**ADDENDUM 002**

**DATE:** August 30, 2019  
**ADDENDUM NUMBER:** 002  
**DG PROJECT NUMBER:** 3050  
**PROJECT NAME:** APS Coyote Willow Family School – Phase 2  
**PROJECT ADDRESS:** 7125 Irving Blvd NW, Albuquerque, NM 87114  
**ISSUED BY:** Wendy E.S. Caruso, AIA, Project Manager

**NOTICE:** *This addendum forms a part of the Contract Documents and modifies the Documents issued by The Hartman + Majewski Design Group and dated September 14, 2018. Acknowledge receipt of this Addendum in locations required on the Pricing Forms. Failure to do so may subject the Proposer to disqualification. All other provisions of the Contract Documents shall remain unchanged. This Addendum contains a total of Thirty One (31) 8 ½" x 11" pages and Six (6) 30" x 42" replacement sheets.*

**S302**

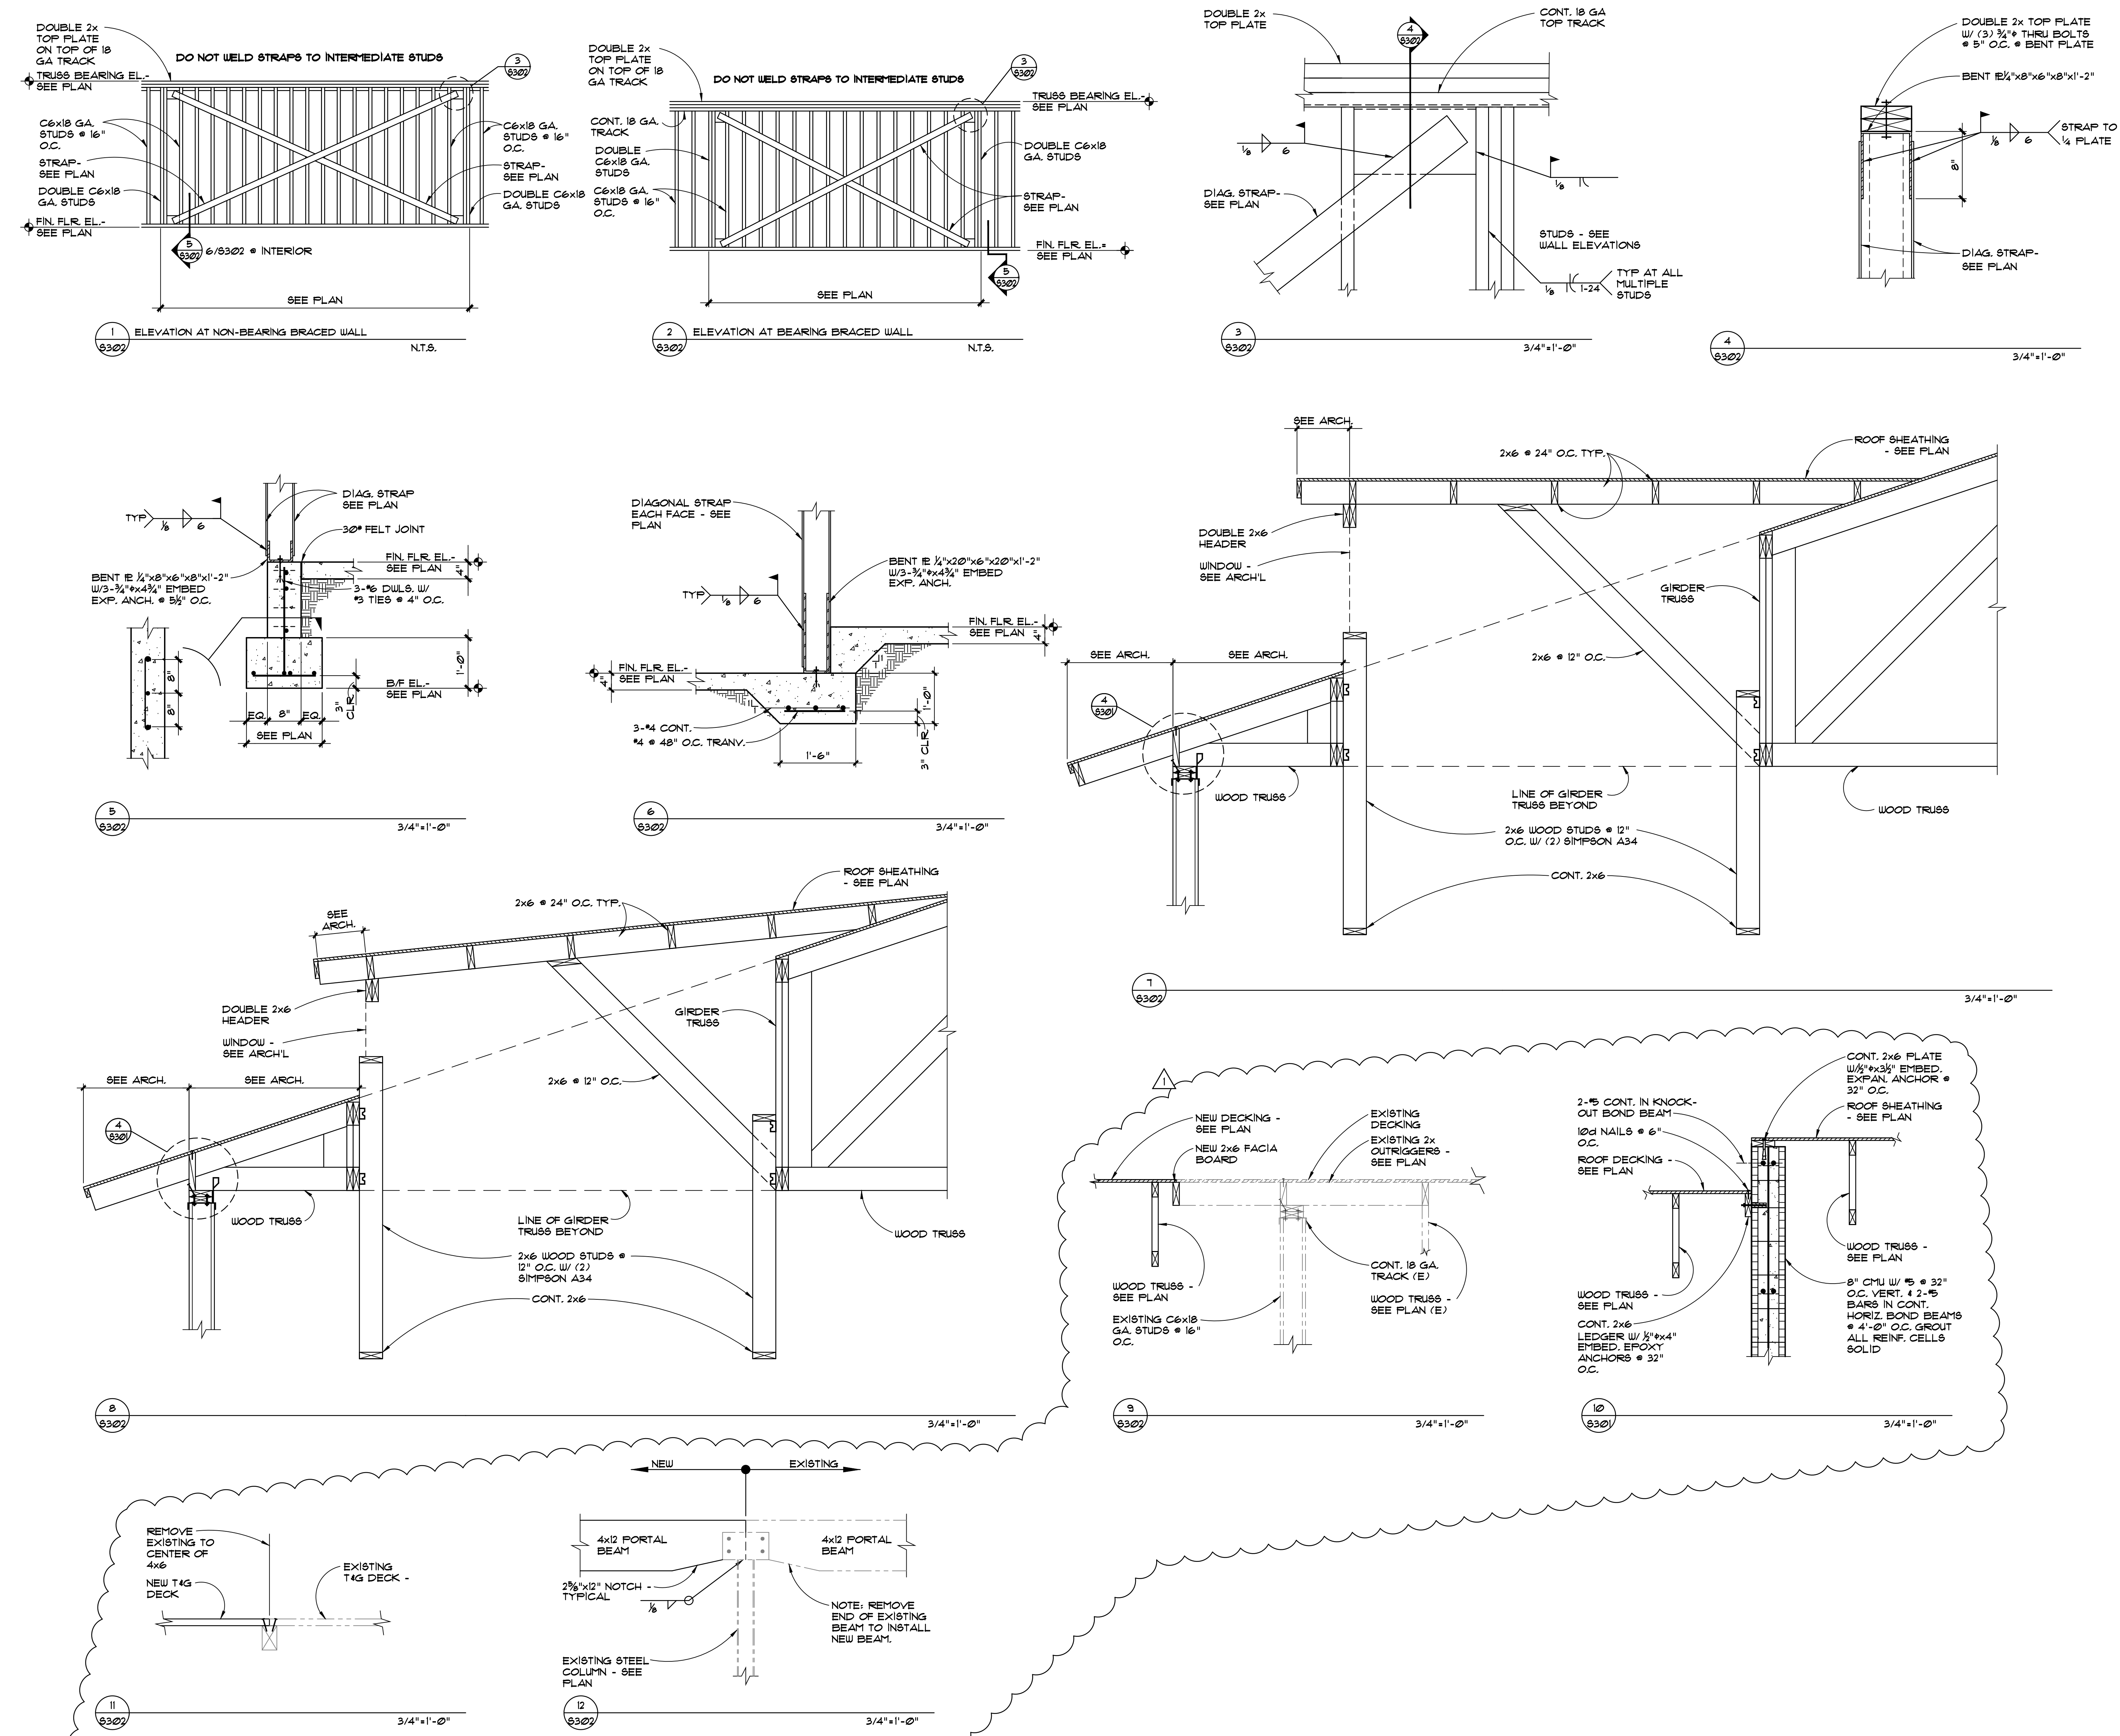
1. Details 9/S302, 10/S302, 11/S302 and 12/S302 are added to describe transition from existing to new construction at the portal
